Access Compliance Report

Public Rights-of-Way

(Curb Ramps)

Intersection ID: 9830	Main Street: ETHEL_GUEST_LN	Cross Street: GERALDINE_POWE_DR	Location: SE
ADA ID: D0E2E808EA52	Ramp Type: PerpDiag	Initial Pass/Fail: Pass	Overall Compliance: No
Severity Score: 0.25			
Codes/Mitigation Info/Possible Solution		Field Measurements/Component Compliance

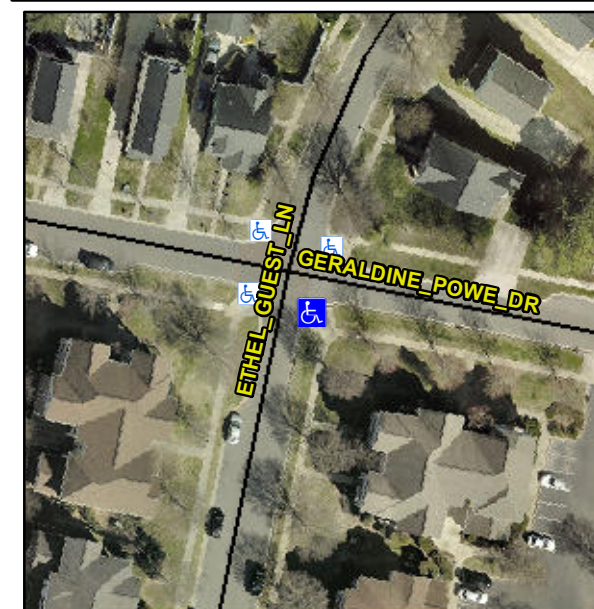
Not Found, R304.5.3, R304.2.2-Perp, R304.3.2-Para

Compliance	Description	Data	Compliance	Description	Data
N/A	Ramp Length (in)	156.2	Yes	Ramp Slope (%)	6.0
Yes	Ramp Width (in)	60.0	No	Ramp XSlope (%)	4.7
N/A	Flare Type LT	Sloped	N/A	Flare Type RT	N/A
N/A	Flare Slope LT (%)	5.1	N/A	Flare Slope RT (%)	11.2
N/A	Flare Traversable LT?	Yes	N/A	Flare Traversable RT?	No
Yes	Landing Length (in)	48.0	Yes	DWS Provided?	Yes
Yes	Landing Width (in)	60.0	Yes	DWS Contrast?	Yes
No	Landing Slope (%)	2.6	Yes	DWS Length (in)	24.0
No	Landing X Slope (%)	3.8	Yes	DWS Full Width?	Yes
N/A	Landing Curb? (Y/N)	No	Yes	DWS Offset (in)	2.0
N/A	Shared Landing?	No			
Yes	Gutter Ponding?	No	Yes	Gutter Slope (%)	3.0
Yes	Gutter Lip Ht (in)	0.0	No	Gutter X Slope (%)	3.5
N/A	Painted X Walk1?	No	N/A	Painted X Walk2?	No
	X Walk 1 Direction	To NE		X Walk 2 Direction	To NW
N/A	X Walk 1 Width (in)	N/A	N/A	X Walk 2 Width (in)	N/A
	X Walk 1 Slope (%)	2.7		X Walk 2 Slope (%)	1.1
	X Walk 1 X Slope (%)	0.8		X Walk 2 X Slope (%)	4.3

N/A	Ramp inside XWalk1?	N/A	N/A	Ramp inside XWalk2?	N/A
	Road Slope (%)	1.7	N/A	Clear Space?	Yes
	Road X Slope (%)	3.3	N/A	Clear Space to XWalk (in)	N/A
Yes	Any Obstructions?	No	Yes	Storm Grate/Utility Hazard?	No
	Obstruction Type			Storm Grate/Utility Type	
		N/A			N/A
			Yes	Surface Condition? (G/P)	Good

Remove & Replace Curb Ramp With Two New Directional Ramps or Equivalent. Remove & Replace Gutter.
